Service Bulletin

Bulletin No.: PIP6032C

Subject: CVT Transmission Leaks from the Oil Filter Housing and/or the Cooler Lines

6750284

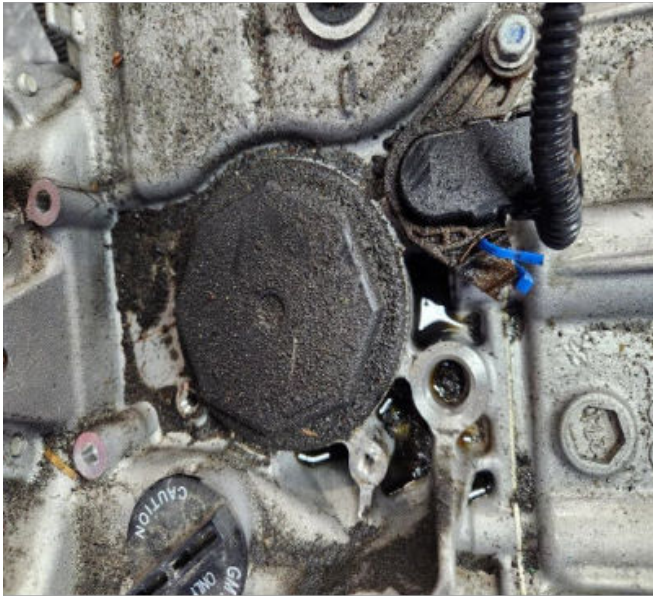
Upon inspection the technician may find a leak coming from the top of the transmission.

This may be caused by a rolled or damaged oil filter housing O ring.

Leak on top of the transmission.

Damaged/Rolled Oil Filter O Ring.

These Seals should always be lubricated prior to installation.

Failure to do so can cause the O Ring to twist and roll or become distorted.

If this concern is found please replace the oil filter housing and take care to lubricate the O ring Prior to installation.

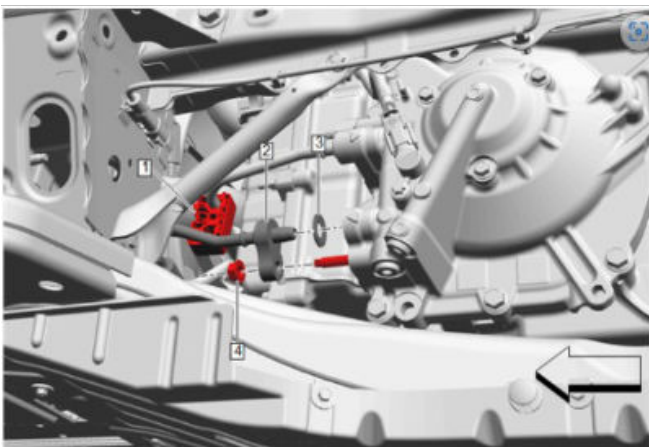
If no leak is seen from the Intermediate Speed Sensor then inspect the oil cooler line inlet ports for leaks.

If no leak is seen from the Intermediate Speed Sensor then inspect the oil cooler line inlet ports for leaks.

There have been cases seen where Technicians or assembly plant issues can leave these seals off.

Take care when removing the lines from the transmission to verify the seals are on the line.

6750295

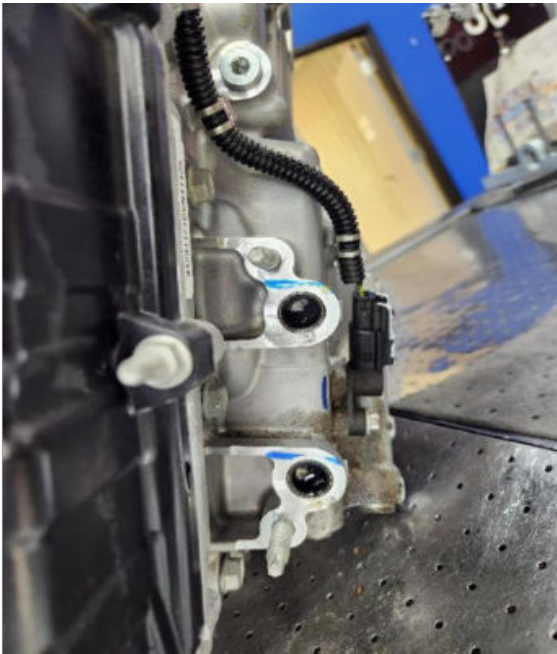
There are secondary shipping seals installed in the cooler line ports on the transmission from the supplier.

The seals are pierced when the cooler lines are installed, and will contain the majority of the leak .

These Seals WILL remain in the transmission and no attempt should be made to remove them as seen in the picture below .

If a leak is found in this location replace the damaged or missing seals, drive the vehicle and verify there are no leaks.
